BULLETIN

Subject: Safety Tethers on units with Flat Bottom Floors

No.: B20012

Re.: Inspection and Repair of Safety Tethers
on units with Flat Bottom Floors

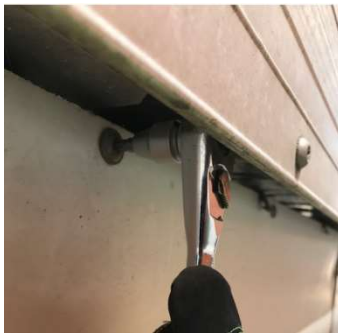
1. Remove the bolt and nut securing the Tether bracket to Skirt panel.

2. Remove the bolt and Tubular nut connecting the two pieces of the Tether assembly.

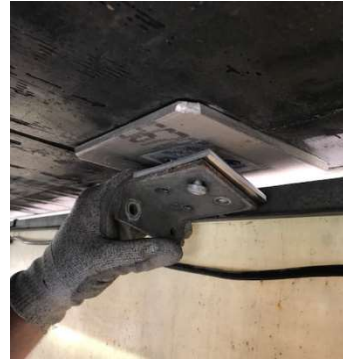
3. Remove the two bolts securing the Angle bracket portion of the Tether assembly to the bottom of the Flat floor. **Note:** It is not uncommon for these bolts to break during removal.

4. If one or both bolts break during removal, locate and mark the holes in the opposite diagonal mounting locations, and drill out for reassembly using a 9/32" Drill bit.

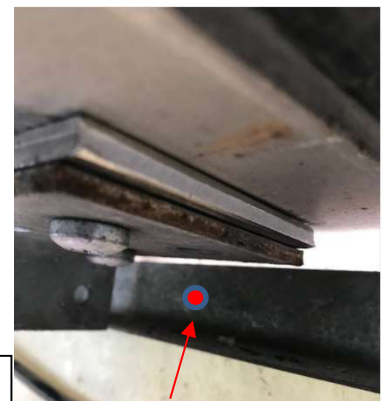
6. Position the provided ¼" Aluminum shim between the Angle bracket and the Aluminum plate on the bottom of the Flat floor.

7. Using bolt part number BLT00155 insert the bolts and tighten.
